UNITED STATES PATENT AND TRADEMARK OFFICE

Office Action Summary	Application No. 10/537,828	Applicant(s) SIM ET AL.	
	Examiner EMILY I. NALVEN	Art Unit 3744

DETAILED ACTION

2. **Claims 1-8 and 14** are rejected under 35 U.S.C. 102(b) as being anticipated by Lee et al. (US Patent No. 5,706,671).

F I G. 1

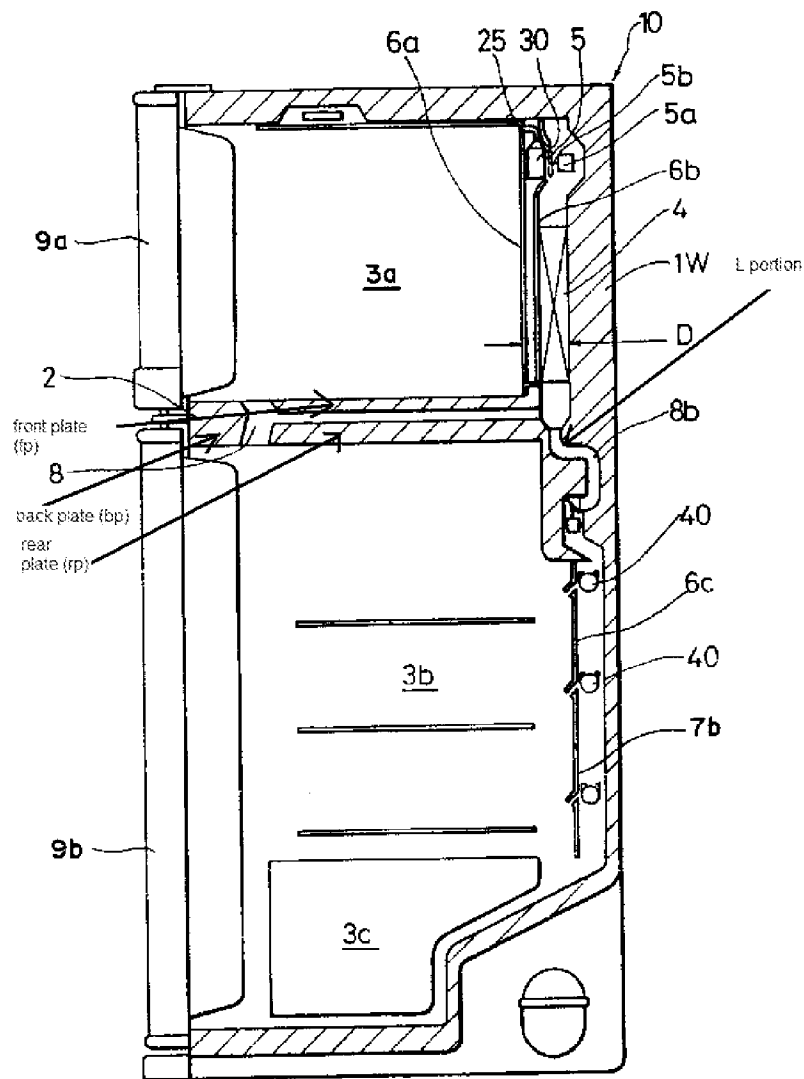
Lee et al. also teach a partition wall (rp) between the freezing chamber cold air passage (passage between 8 and 8b) and the refrigerating chamber cold air passage (7b) (see annotated Fig. 1 below), the evaporator (4) passing through the partition wall (rp) such that the evaporator (4) is exposed to the freezing chamber cold air passage and the refrigerating chamber cold air passage (see annotated Fig. 1 below). The evaporator (4) is directly exposed to the freezing chamber (3a) and separated from the freezing cover by the casing of the evaporator (6a) (see annotated Fig. 1 below). The piping of the evaporator (4) and lower portion of the evaporator passes through the back end of the refrigerating chamber (3b) passing through the very right bottom end of the partition wall (see Fig. 1). A pipe is considered to be a hollow cylinder used to convey a medium meeting the limitations of a passage which is an opening used to convey something.

Lee et al. also teach a fan (5) mounted over the freezing chamber cold air passage (passage between 8 and 8b) and the refrigerating chamber cold air passage (7b) (see Fig. 1 and col 1 lines 22-23) for discharging cold air flowing through respective cold air passages (7b, 8) to the freezing chamber (3a) and the refrigerating chamber (3b), respectively (see Fig. 1). The fan (5) forces air into the freezing chamber (3a) and refrigerating chamber (3b) using the partition plate (6b) to direct the airflow of the coming from the fan (5). It is presumed that the fan

In regard to claim 2, Lee et al. teach the refrigerator (10) wherein the evaporator (4) includes a first part exposed (exposed through vent 6a – see Fig. 1) to the freezing chamber cold air passage (passage between 8 and 8b) (see Fig. 1) and a second part (8b) exposed to the refrigerating chamber cold air passage (7b) (see Fig. 1). The face of the evaporator adjacent to the vent 6a is exposed to the chamber cold air passage via the duct 8. The second part (8b) tubing extends from the bottom side of the evaporator (4) to enter the refrigerating chamber cold air passage (7b).

In regard to claim 3, Lee et al. teach the refrigerator (10) wherein the first part (6a) is larger than the second part (8b) (see Fig. 1). The surface area of the first part (6a) facing the freezing compartment (3a) is larger than the surface area of the second part (8b) facing the opening to the refrigerating compartment (3b) (see Fig. 1).

In regard to claim 4, Lee et al. teach the refrigerator (10) wherein an outer surface of the first part (6a) and the second part (8b) is separated by the partition wall (rp) for preventing the cold air flowing through the respective parts from mixing with each other (see Fig. 1).

In regard to claim 5, Lee et al. teach the refrigerator (10) wherein the partition plate (rp) includes a front plate (fp) and a back plate (bp) to form a cold air passage (see passage between fp and bp connected between passage 8) between the plates (fp, bp) (see annotated Fig. 1 above).

In regard to claim 6, Lee et al. teach the refrigerator (10) wherein the front plate (fp) has a plurality of cold air discharge openings (opening at 8 and opening at

8b) formed therein (see annotated Fig. 1 above). The front plate has an opening to let air exchange between the refrigerating chamber (3b) and freezing chamber (3a) via opening 8. There is a second opening above 8b to let air exchange with the fan and evaporator (4) as seen in annotated Fig. 1 above.

In regard to claim 7, Lee et al. teach the refrigerator (10) wherein the back plate (bp) has an opening in an upper part thereof (into 8b) and the fan (5) is provided adjacent to the openings (8, 8b) (see Fig. 1). The fan (5) is adjacent via the evaporator (4) (see annotated Fig. 1 above).

In regard to claim 8, Lee et al. teach the refrigerator (10) wherein the partition plate (1w) has openings (8, 8b) in a lower part thereof to form cold air suction openings (see annotated Fig. 1 above). The front plate has an opening to let air exchange between the refrigerating chamber (3b) and freezing chamber (3a) via opening 8. There is a second opening above 8b to let air exchange with the fan and evaporator (4) as seen in annotated Fig. 1 above.
